YEAR 5 MONITORING REPORT

**ROSES CREEK STREAM MITIGATION SITE
Burke County, North Carolina
NC DMS Project # 96309**

Re: Monitoring Year 5 Response to Comments
Roses Creek Stream Restoration Project
Burke County, North Carolina

SHEET
3

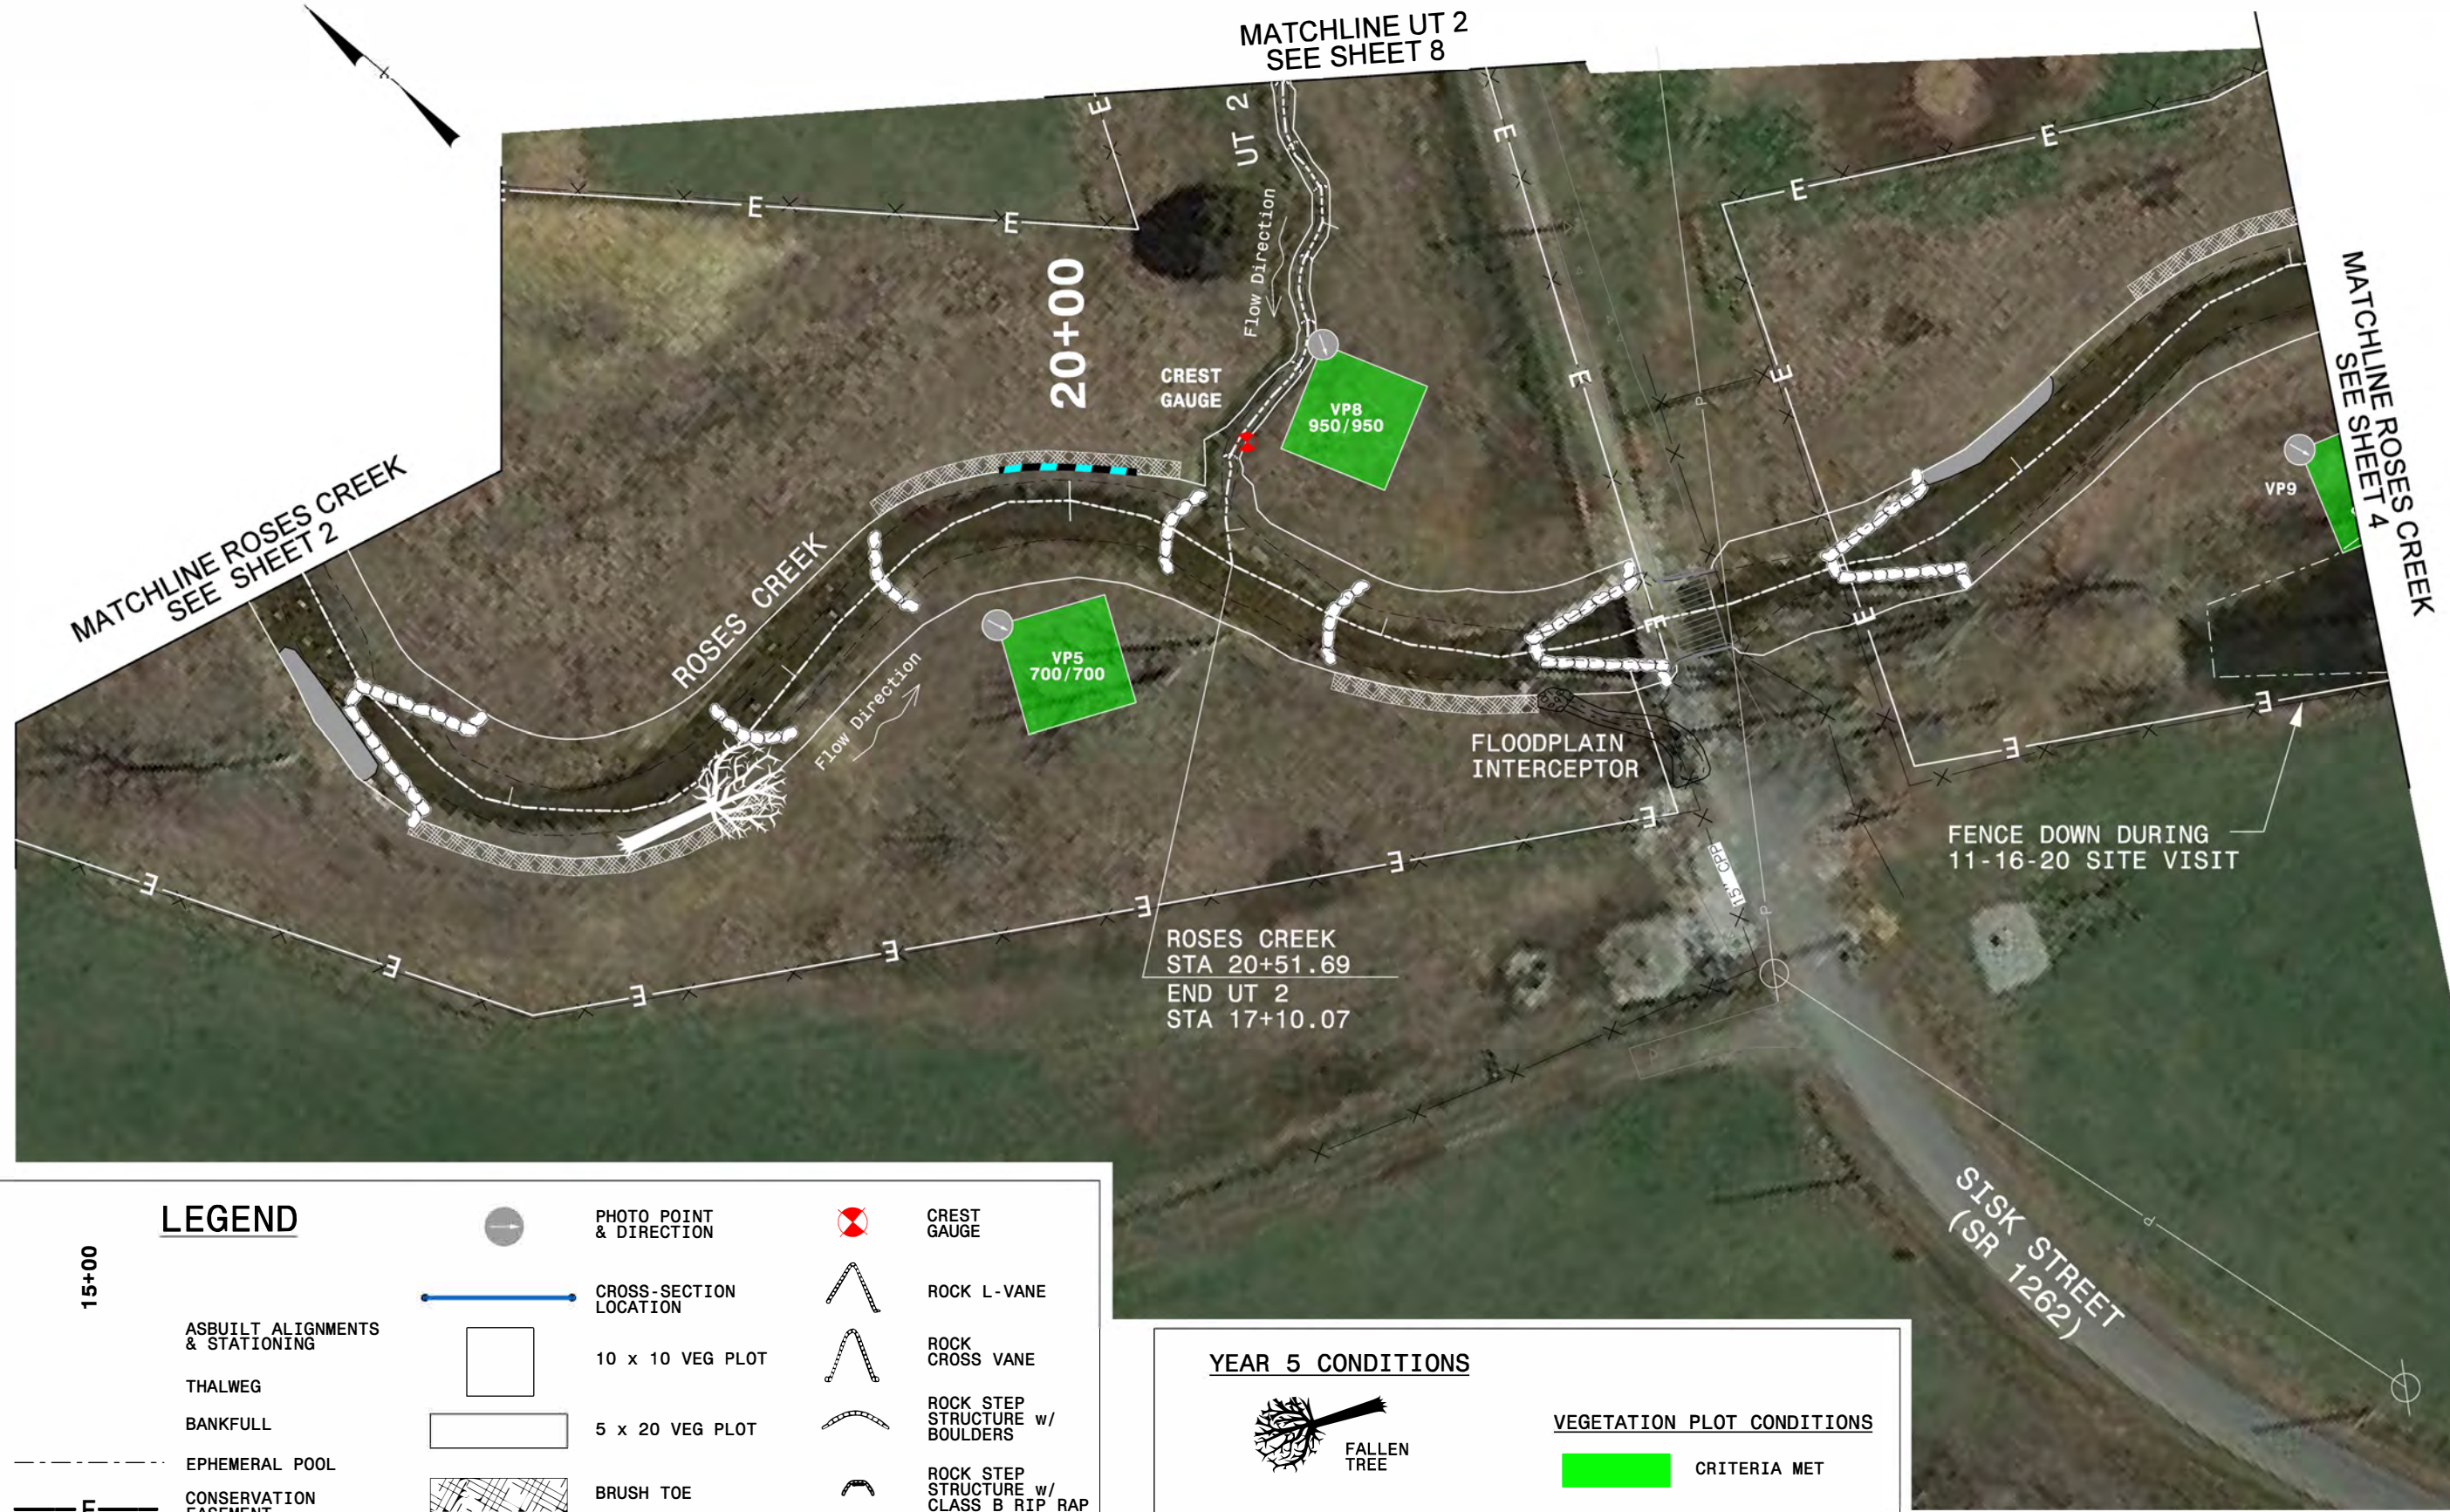
11. Has the downed fencing been fixed yet? This is an area adjacent to cattle pasture.

RE: The landowner has been made aware of the downed fence. LMG cannot confirm that the fence has been repaired at this time, but LMG is working with the landowner to address the damaged area.

Figure 4.11

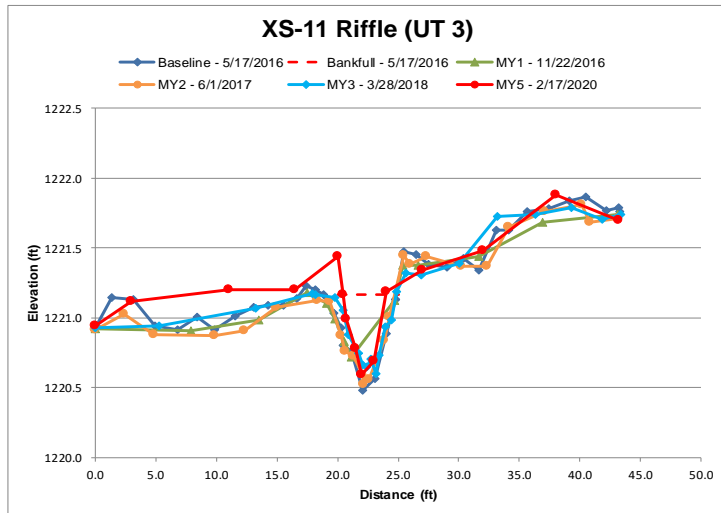
12. Please review cross section BHR calculations. Cross section 11 is reported to have a BHR of 1.16, but the BHR should be 1.4. This is being caused by an inaccurate MY0 bankfull cross sectional area (e.g. 2.19 vs. 1.4). This was verified using the Mecklenburg spreadsheet and the DMS cross section tool. The MY0 cross sectional area for XS7 also appears to be inaccurate (e.g. 2.3 vs. 1.9), so please review the MY0 cross sectional areas to determine how these affect MY5 BHR's. Additionally, for cross section 10, there is a greater than symbol. For other cross sections where the BHR is >1 the actual value is reported, so please do this for XS 10.

RE: The geomorphology values in the Cross Section tables for Cross Section 11 has been updated in this resubmittal of the report to correspond to the cross section geometry presented in the graph.

Respectfully, Land Management Group does not agree with the sentiment that the Baseline bankfull elevation should be adjusted. The bankfull geometry for XS 7 and XS 11 was submitted and approved as part of the Baseline Monitoring report. All geomorphology data for XS 7 and XS 11 over the last 4 monitoring years has been calculated based on the baseline bankfull elevation/ cross sectional area, therefore LMG does not see any reason to modify the baseline geometry in Year 5. With this in mind, LMG believes that the bank height ratios of <1 and 1.12 for XS 7 and XS 11 respectively, are correct based on DMS guidelines for BHR calculation.

Figure 5.3 UT 3 Water Level

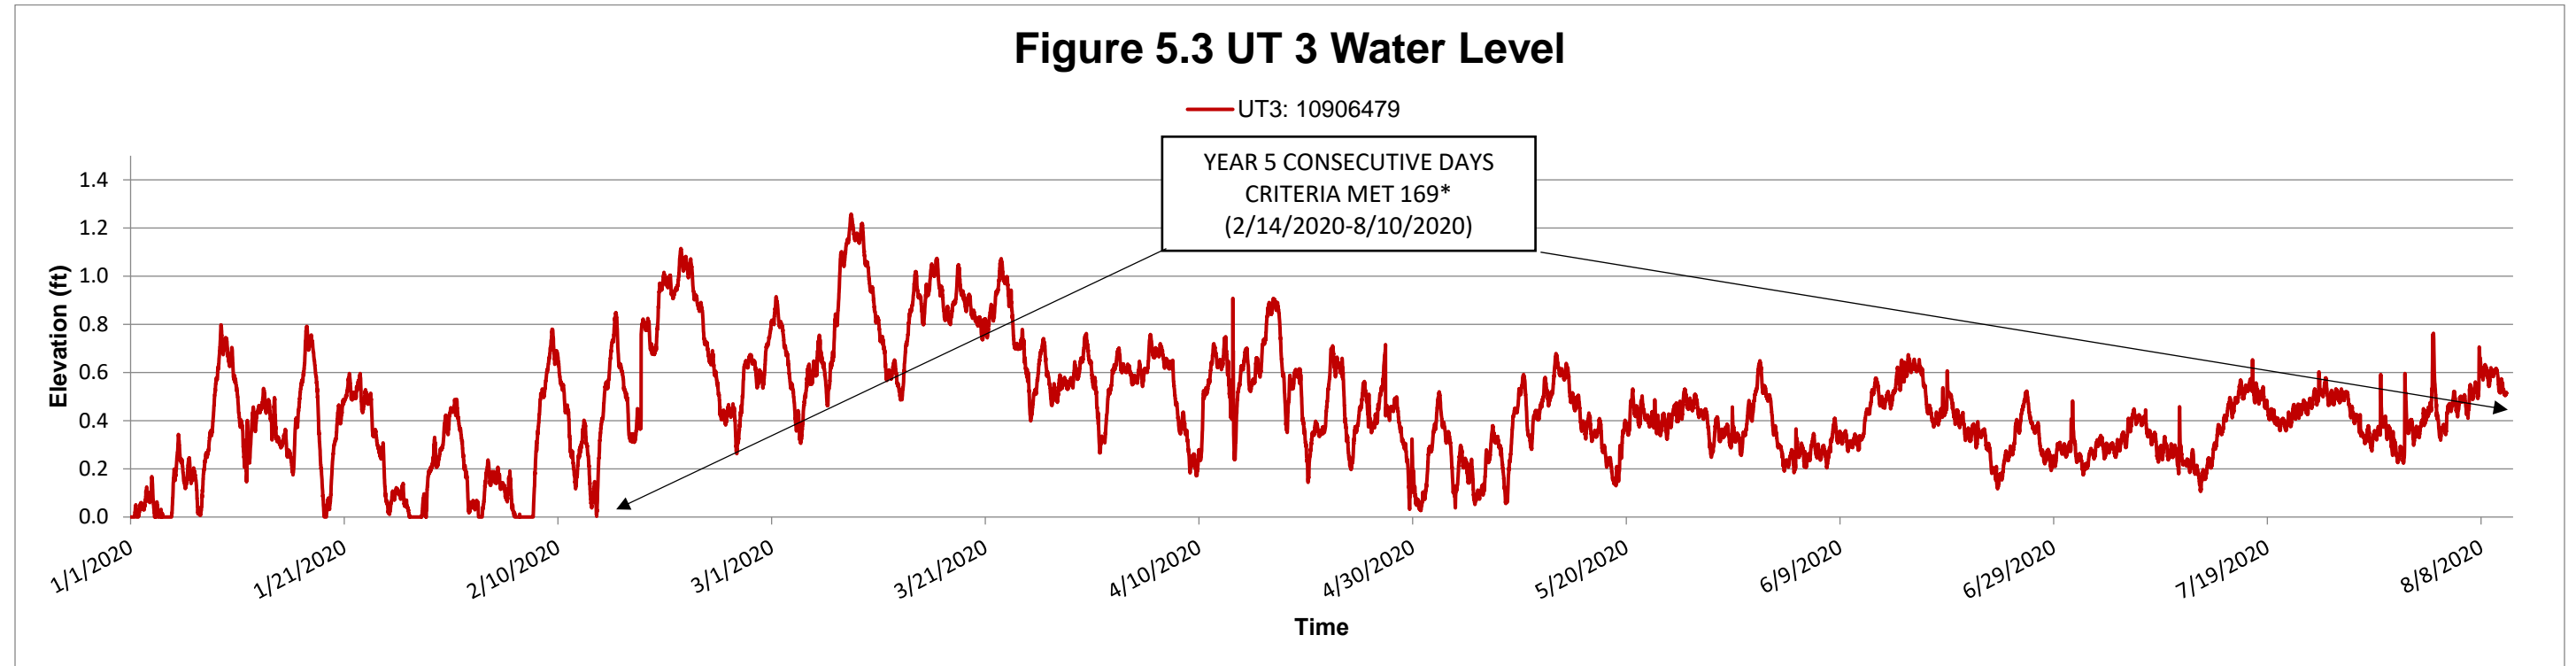
3. Fig 5.3 x-axis label has distance rather than time as a label. This was also an issue in the prior (MY4) annual report.
RE: Comply. Figure 5.3 x-axis has been revised to show time.
